Review of Plans: Tri-Bee LTD, 120 & 122 East Central Avenue, Pearl River, NY
Section 68.20 Block 2 Lots 5.1 & 5.2 CS zone

Applicant: Tri-Bee LTD. 120 & 122 East Central Ave Site Plan

Subject: **Tri-Bee Site Plan**
Prepreliminary/ Preliminary/ Site Plan
and SEQRA Review
120 & 122 East Central Avenue, Pearl River
68.2-/2/5.1 & 5.2; CS

**PB#23-06: Tri-Bee Site Plan
Town of Orangetown Planning Board Decision
Preliminary Site Plan Approval Subject to Conditions**

SHEET 2

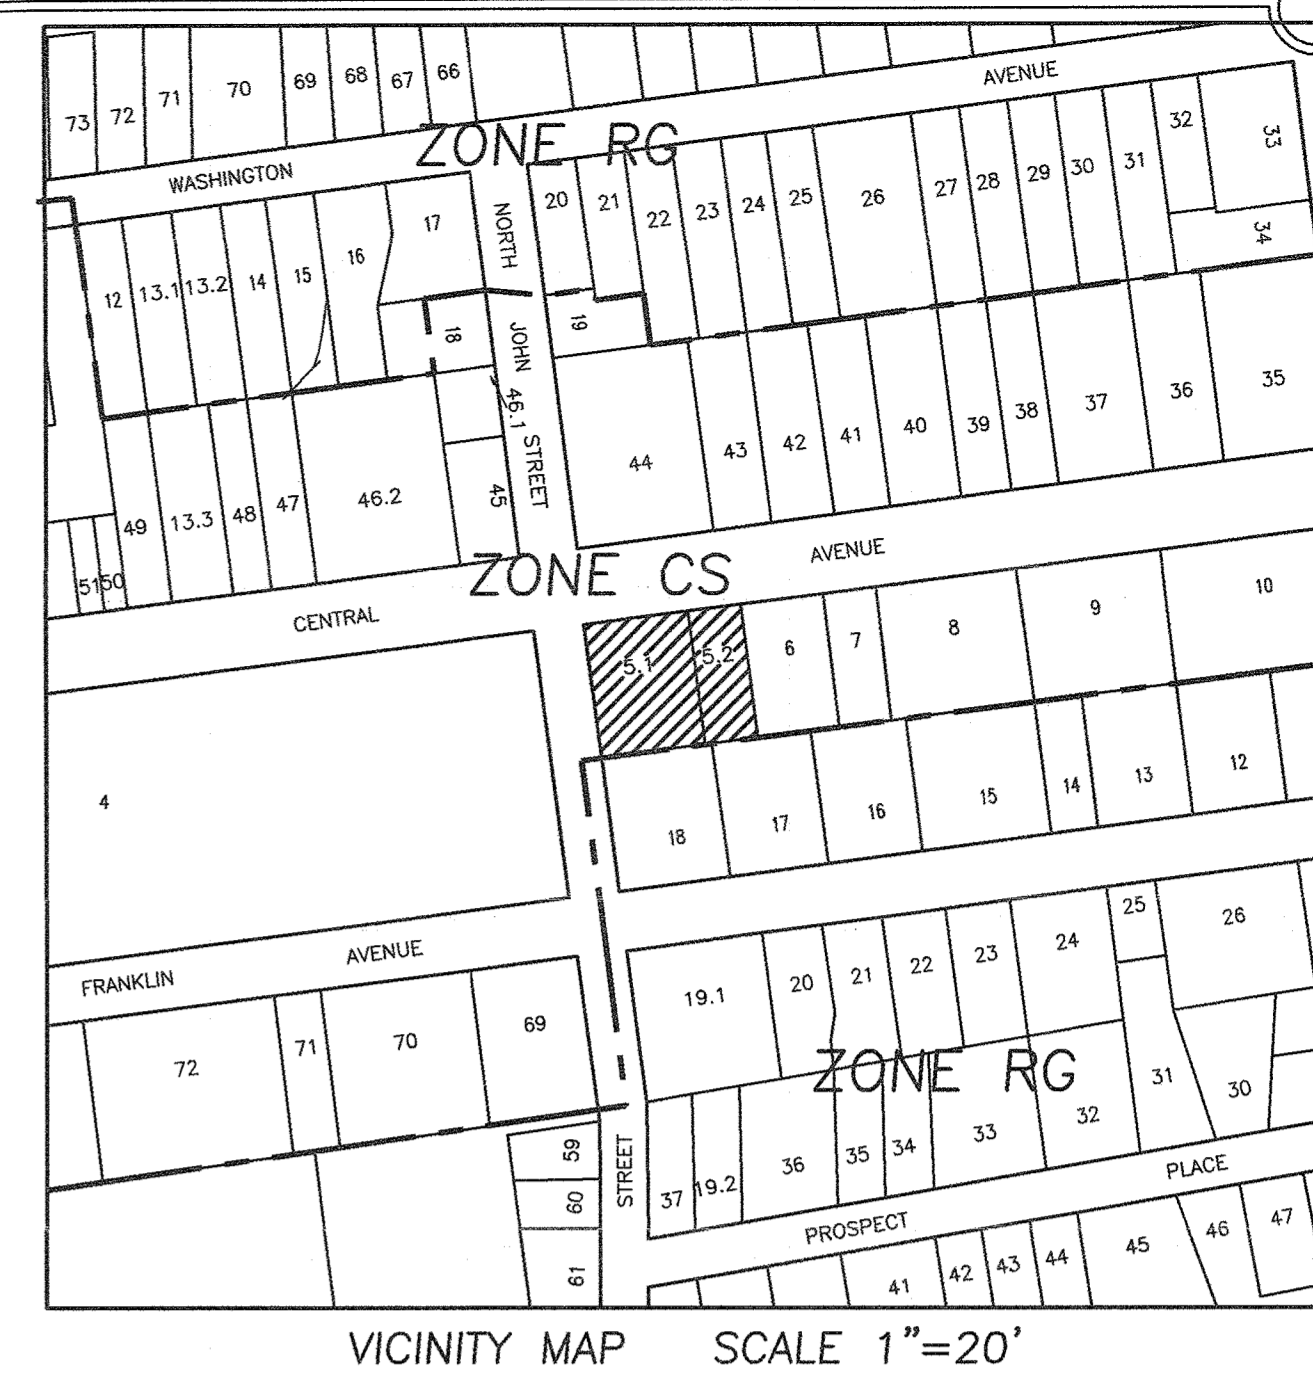
16). Near the northwest corner of the building, the site plan illustrates a stairway and a concrete walkway to be constructed where two parking spaces are proposed. The location of this walkway will limit the amount of room available for a vehicle to park in either of these spaces. This is also unsafe and creates potential for conflict between a pedestrian descending the staircase and a vehicle entering one of the spaces. The sidewalk and the parking spaces must be reconfigured.

17). The site plan proposes eight parallel parking spaces near or adjacent to the outer walls of the structure. The use of parallel spaces, as opposed to perpendicular parking, may result in vehicle tailpipes being only a few feet from apartment windows. Pollution from idling vehicles may have a serious impact on indoor air quality for residents, depending on the location of windows. The Planning Board must consider the potential health impacts of this parking layout and consider relocating the parking spaces to a greater distance from the structure.

18). As noted in the previous comment, several of the proposed parking spaces are adjacent to the structure. The site plan must be amended to include protective bollards, particularly around the window wells, electric box, and entry stairs along the southern side of the structure.

19). The site plan must be amended to include a "Do Not Enter" sign at the northwest exit to prevent vehicles from entering.

SHEET 3

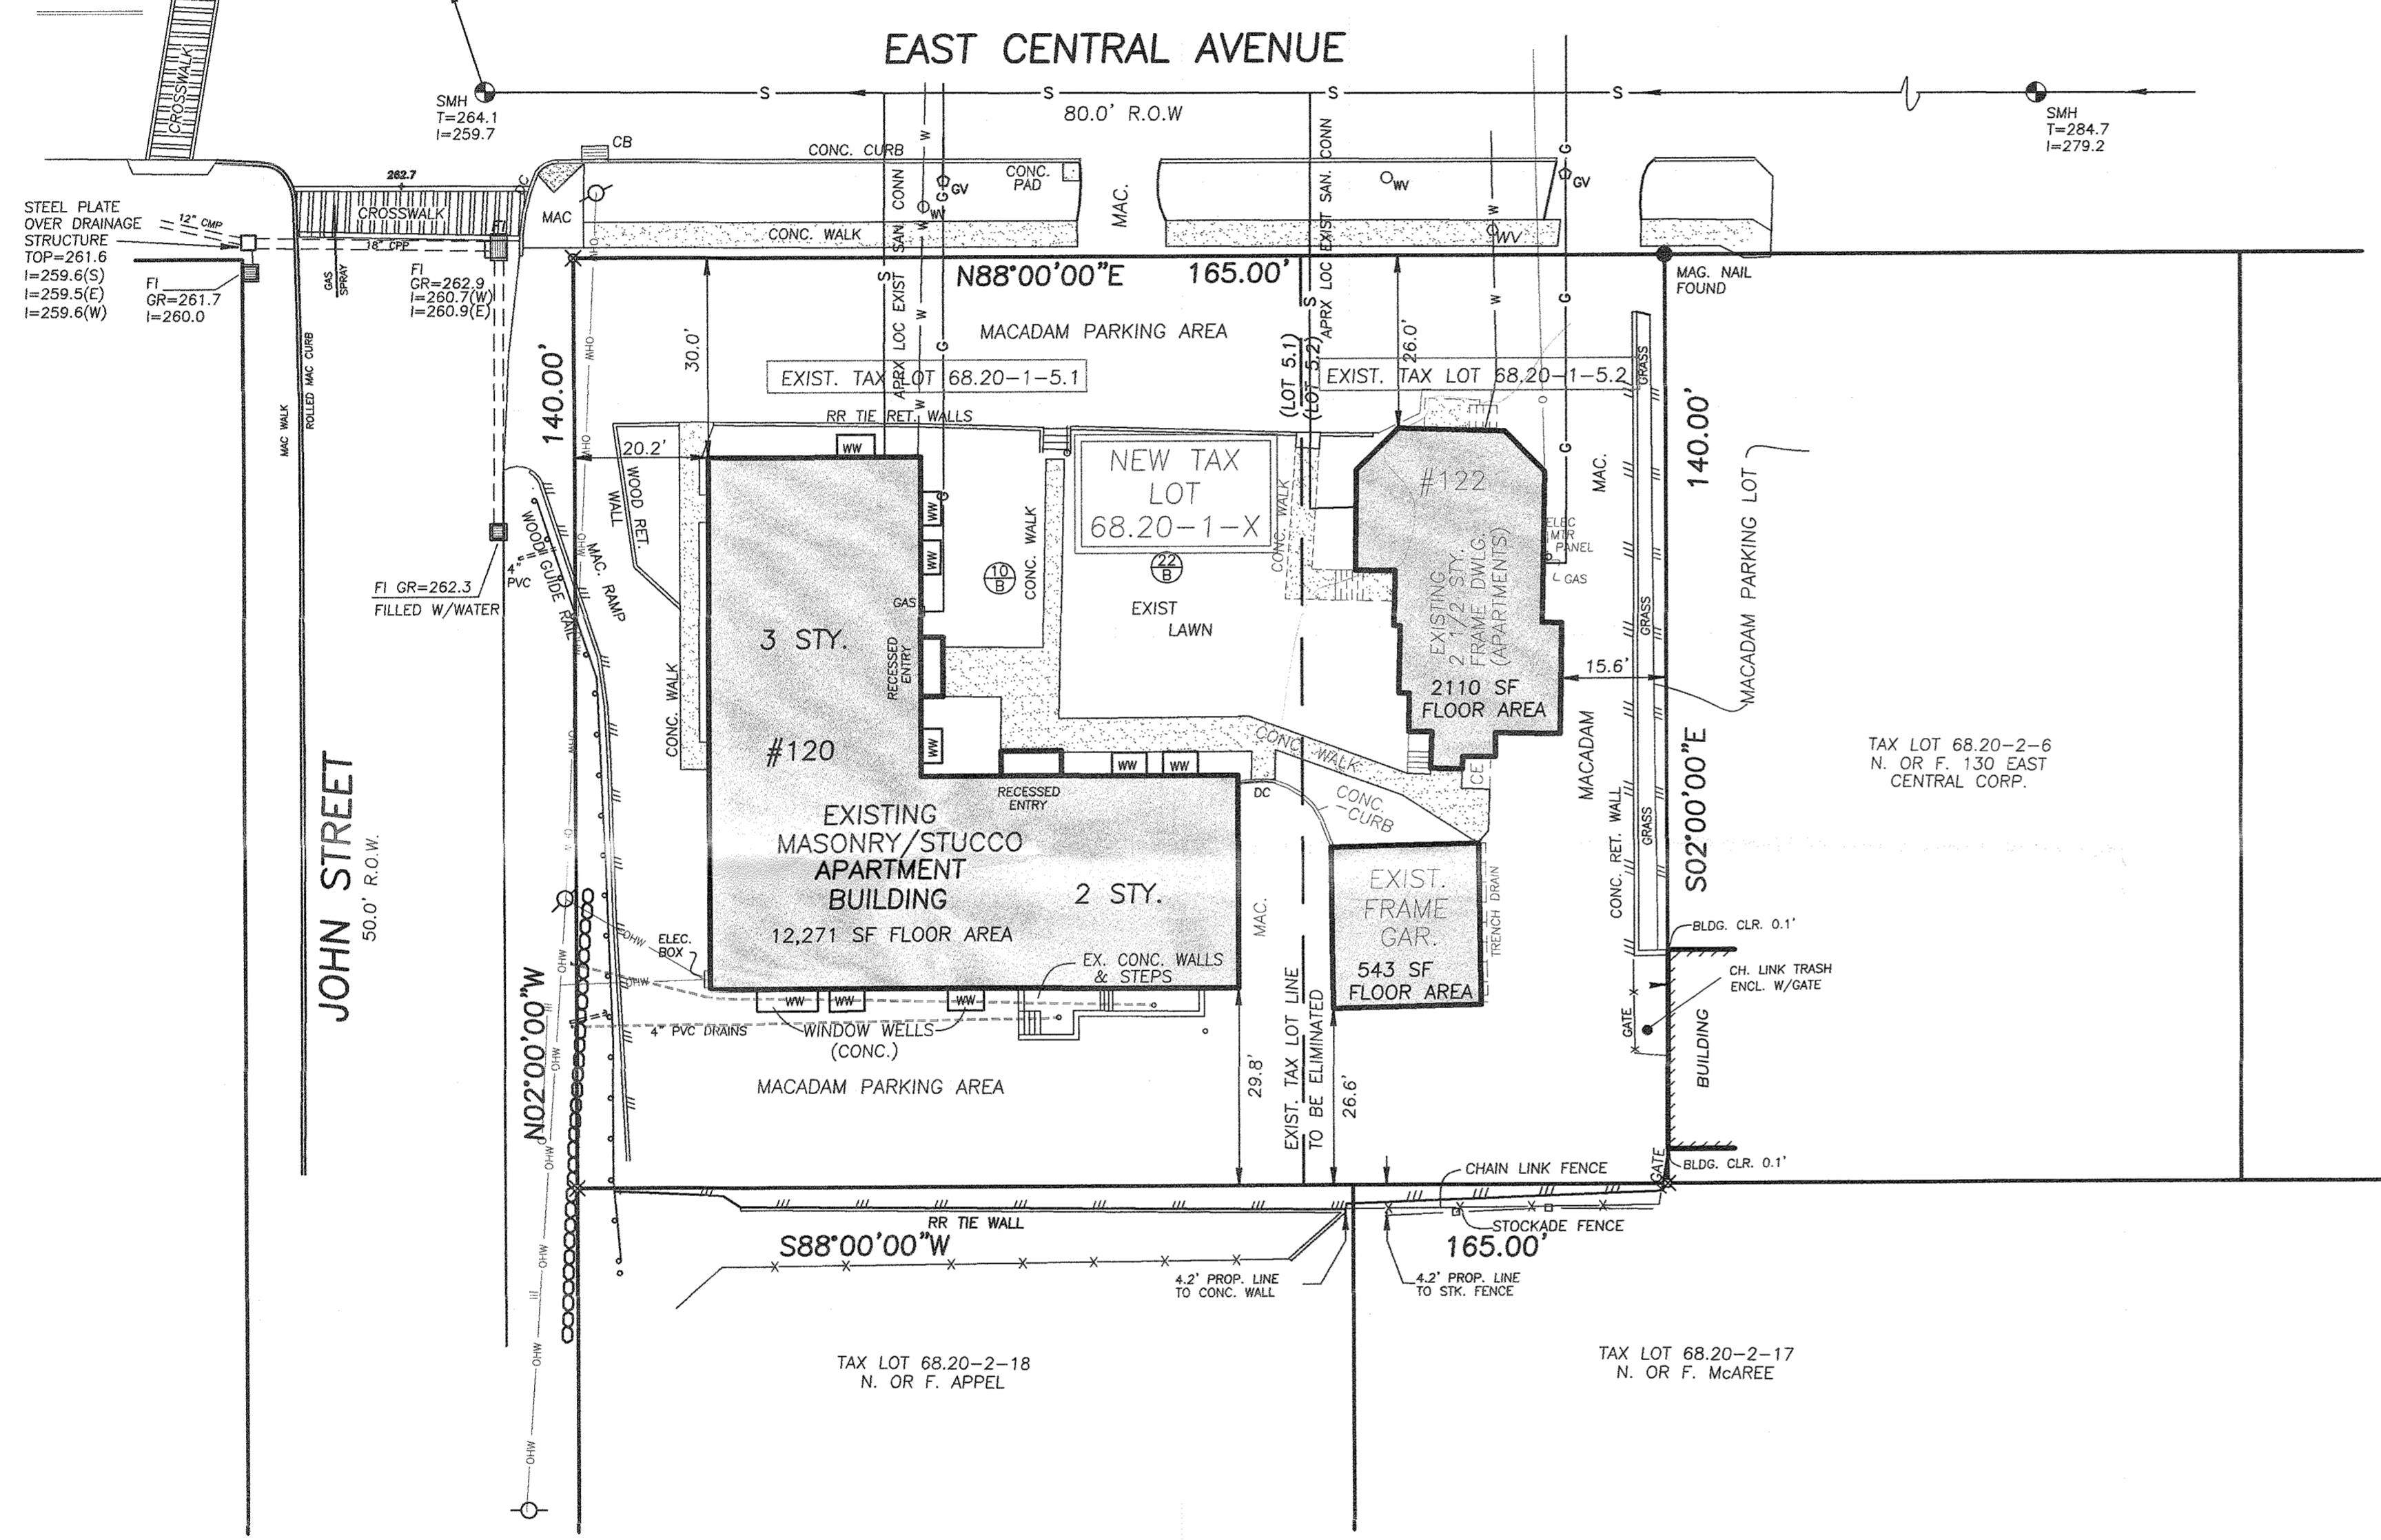
25.1). Map note#16 on Sheets 1 and 3 of the site plan states that the water supplier is United Water of New York. The map note on both sheets must be corrected to Veolia North America.
